SEWAGE DISPOSAL SYSTEM

DEPARTMENT OF HEALTH AND MENTAL HYGIENE

ADDRESS 9429 Old Frederick Road Ellicott City, MD 21042 PHONE (410) 465-8896

SUBDIVISION _____ LOT _____ ROAD 3765 Ivory Road

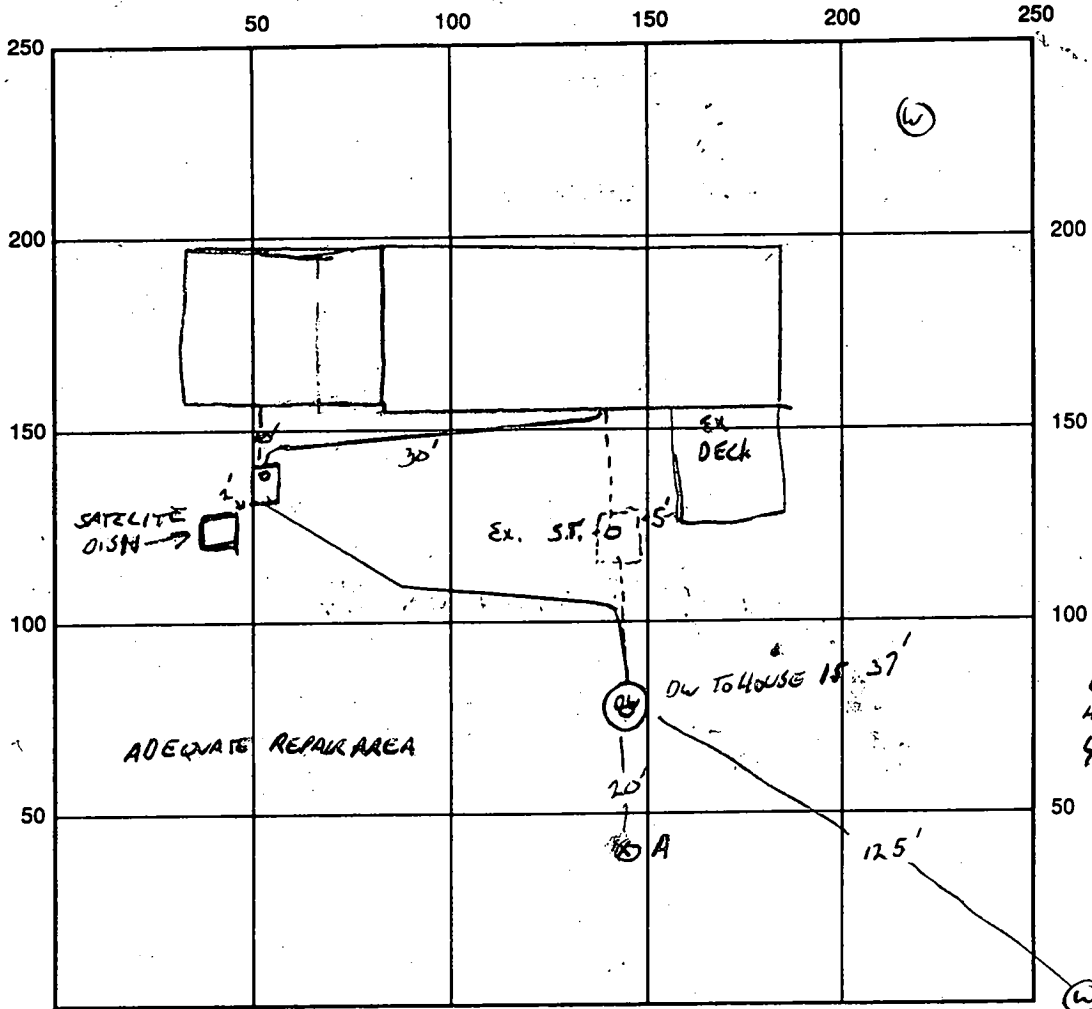
NEW TANK TO BE 10' FROM PROPOSED ADDITION + EXISTING GARAGE/DECK

ADDITION OF 45' TRENCH ADVISED INLET 4' BOTTOM 8'

REMARKS: 10/21/96 EXISTING TANK TO BE REPAIRED FOR BUILDING PERMIT, ^{+RELOCATED}
OK TO SET NEW TANK BETWEEN DECK AND SATELLITE DISH (GIVES 3' CLEARANCE
TO POSTER 5) FOR DECK - CONTRACTOR SAYS THAT REMOVAL OF TANK WOULD DESTROY
DECK OWNER DECLINED ADDITION TO SEPTIC FIELD. 10/22/96
EXISTING TANK ABANDONED, NEW TANK INSTALLED. ALL ANGLED FITTINGS ARE 22°
BROKEN UP + REMOVED

SITE INFO FOR B.P.

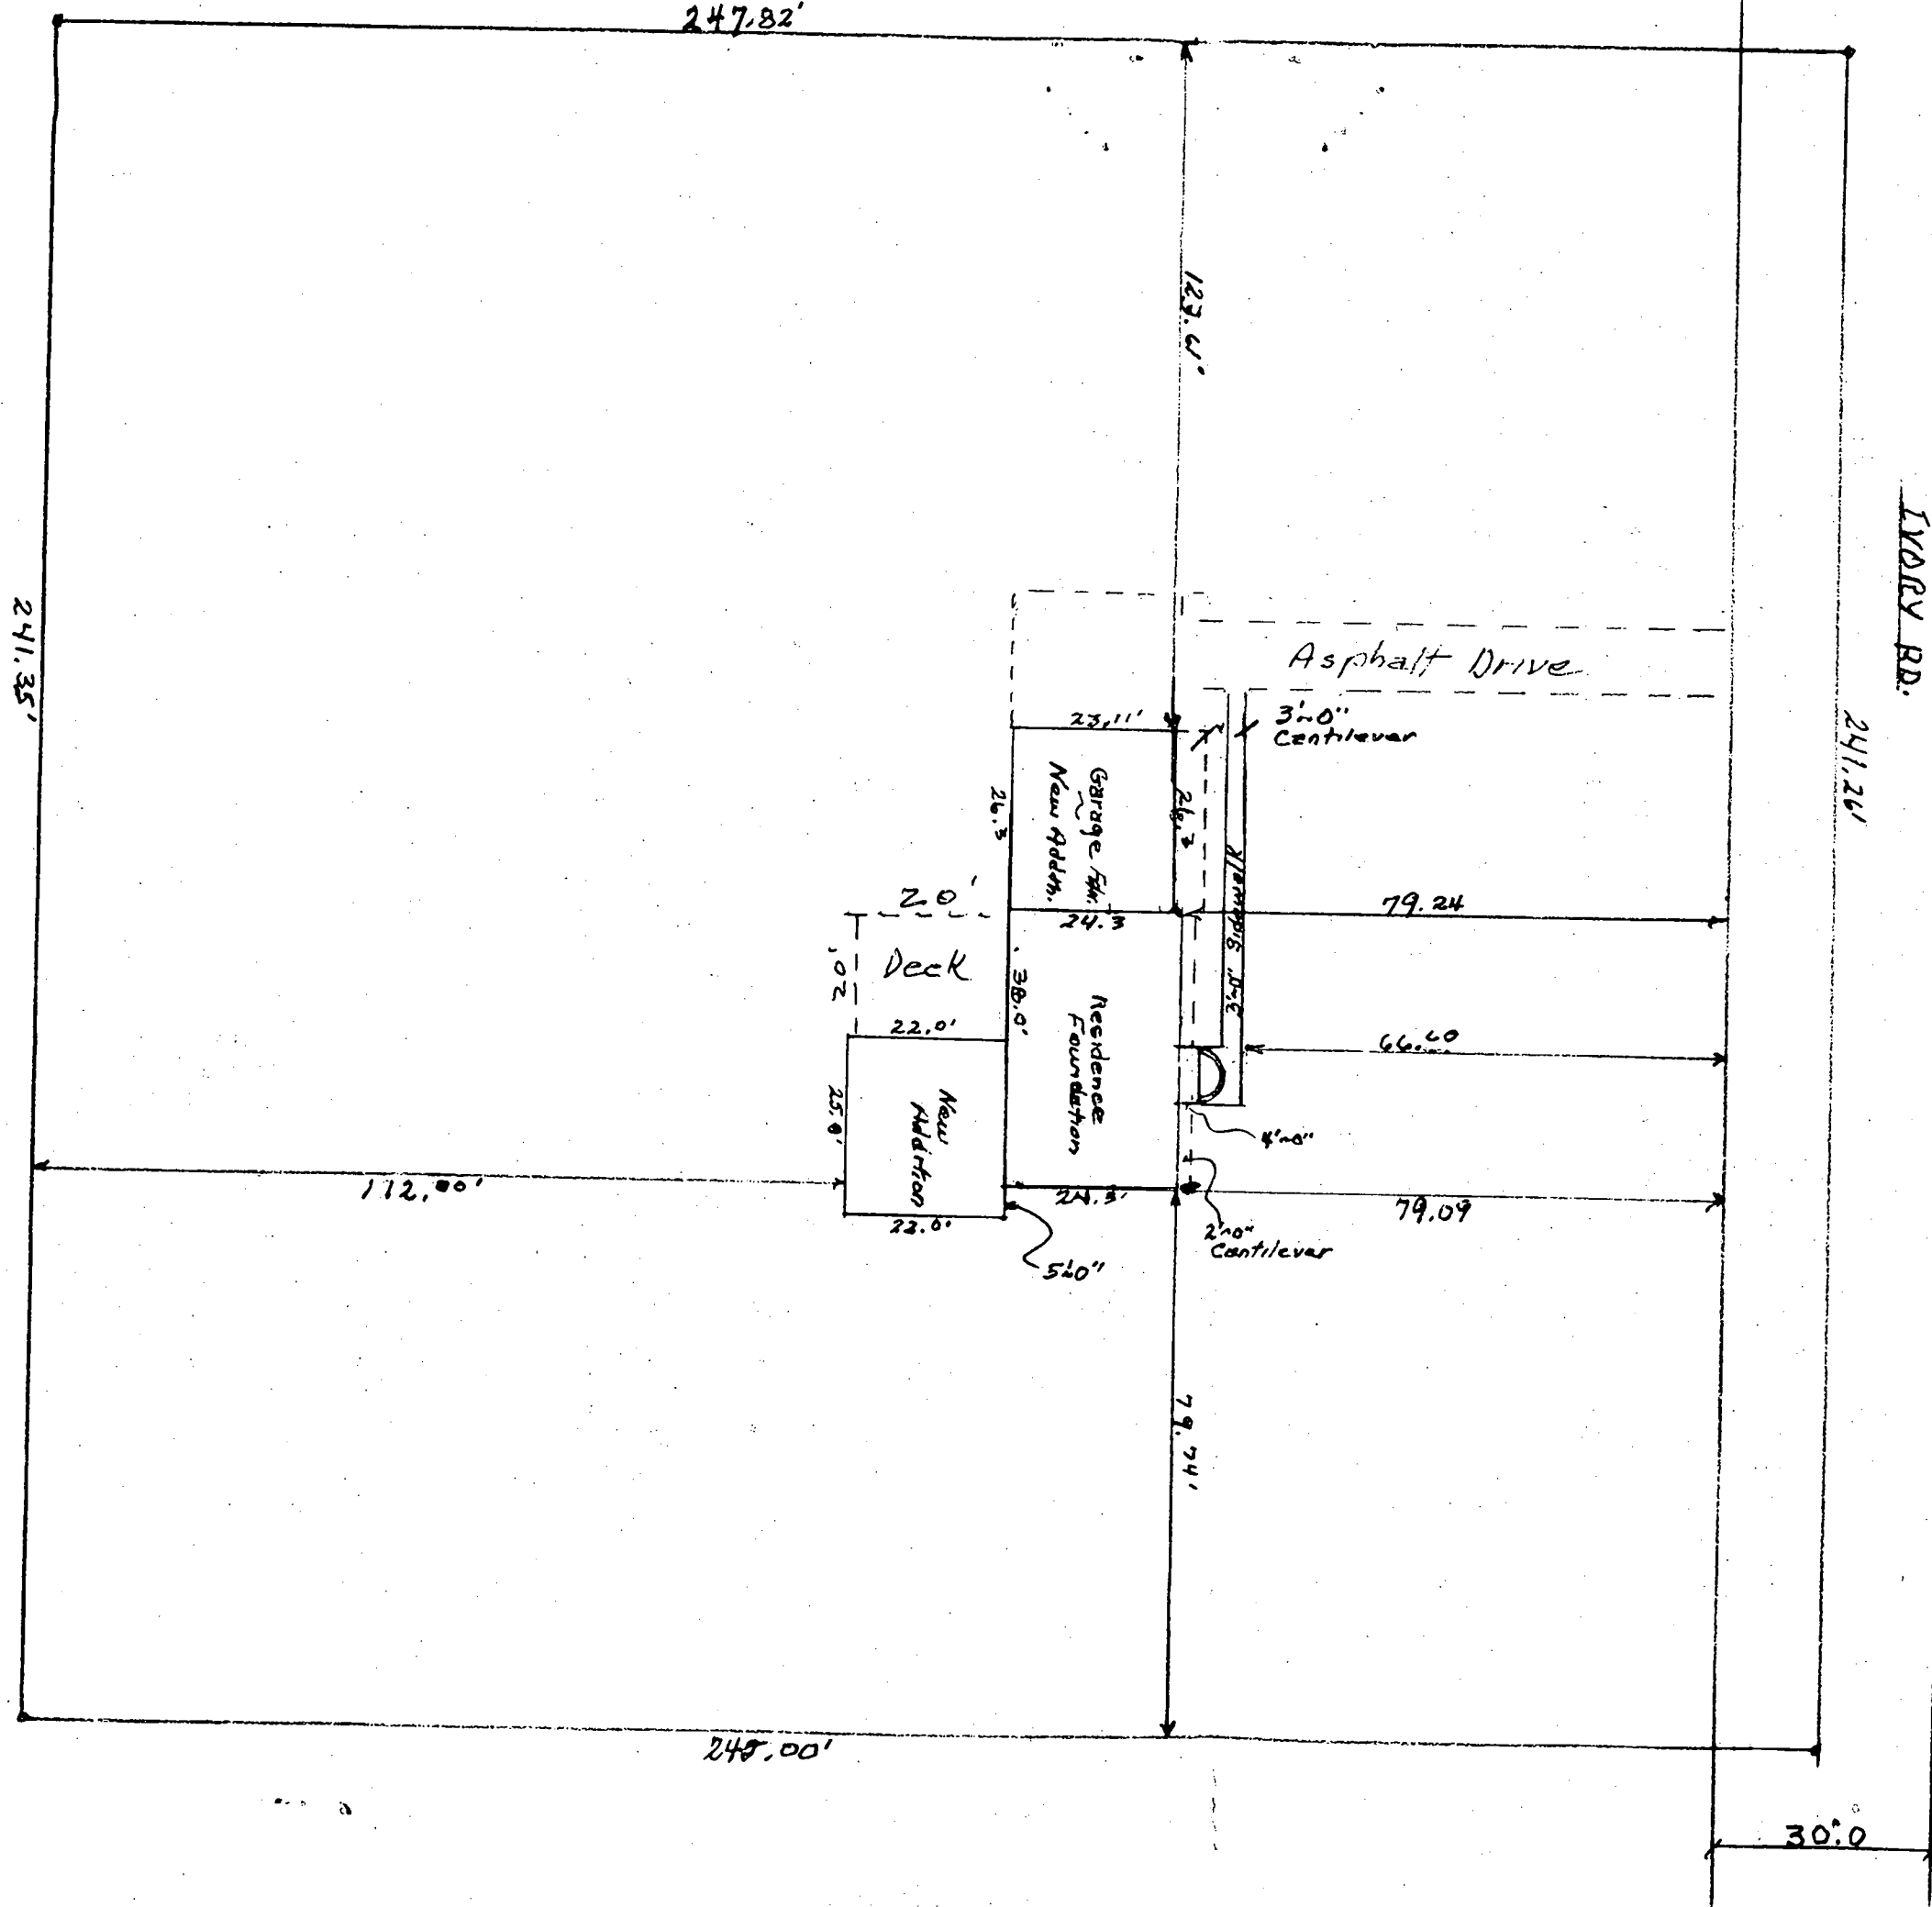
TANK TO BE RELOCATED TO THIS AREA
NO CHANGE IN # BORMS
RECOMMENDATION THAT ADDITIONAL
TRENCH BE ADDED - NOT REQUIRED.
OK TO RELEASE B.P. UPON
COMPLETION OF TANK RELOCATION/
ABANDONMENT. *ff*

OW 7' TO WATER LEVEL

EXISTING DRYWELL APPEARS
TO BE FUNCTIONING OK

COMPLETE OK TO RELEASE B.P.
ff
